御中		Issue No. / 発行№ : PC-0025946			
		Issue date / 発行日 : 2023/2/21			
工程変更連絡書 Process Change Notice		ヒロセ電機株式会社 郡山工場 品質管理課 Koriyama Factory, Quality control section, Hirose Electric Co., Ltd.			
		承認 (Approval)	査閲 (Review)		
		塚本 Tsukamoto	稲垣 Inagaki		
		作成 (Created by) 野内 Nouchi			
貴社益々ご清栄のこととお喜び申し上げます。日頃は弊社製品のお引き立てを賜り、厚く御礼申し上げます。 早速ですが、貴社への納入製品について、下記の通り工程変更を計画しております。 本書にて工程変更のご案内をさせていただきます。変更計画可否を提出後 2週間以内にご返却を賜りたくお願い致します。 We truly appreciate your significant support always. We are currently planning on the below process change for the products planned to be delivered to your company. Forwarding shares the notification of the process change. Your approval for the change plan within 2 weeks will be appreciated.					
貴社品番/Customer's product number		弊社品番/Product number by Hirose			
		DX30M-50-CV			
230-5055-8		DX30M-50-CV(10)			
230-5055-8 10					
Content of change / 変更内容	Change 1	区分 Type	理由 Reason

Issue No. / 発行№ : PC-0025946

"HRS" mark comparison

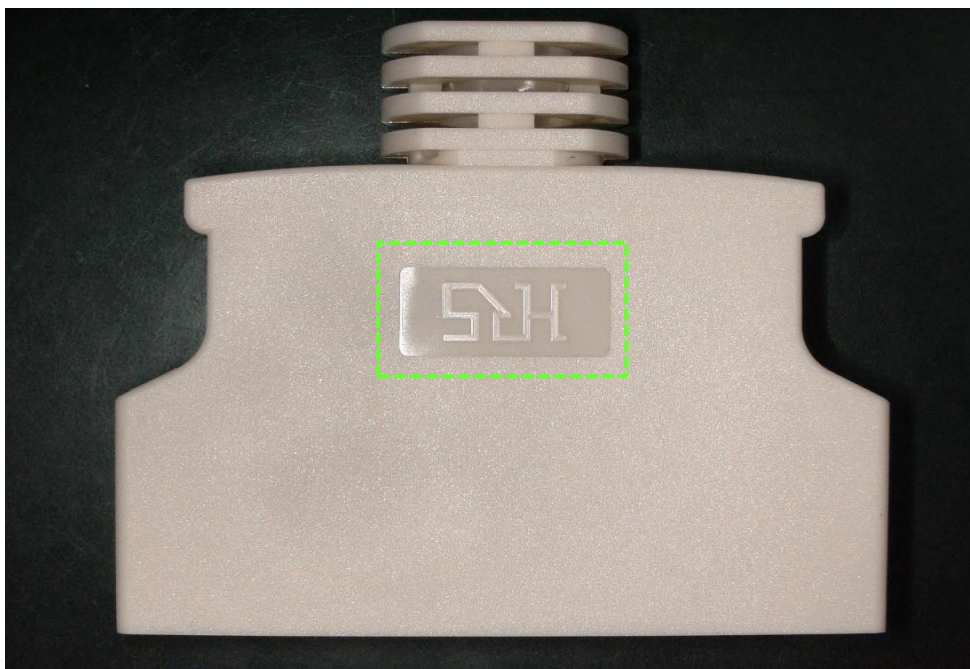
HQS mark appearance by existing mold

HQS mark appearance by replaced mold

※ "HRS" mark appearance will slightly change due to a renewal of mold.
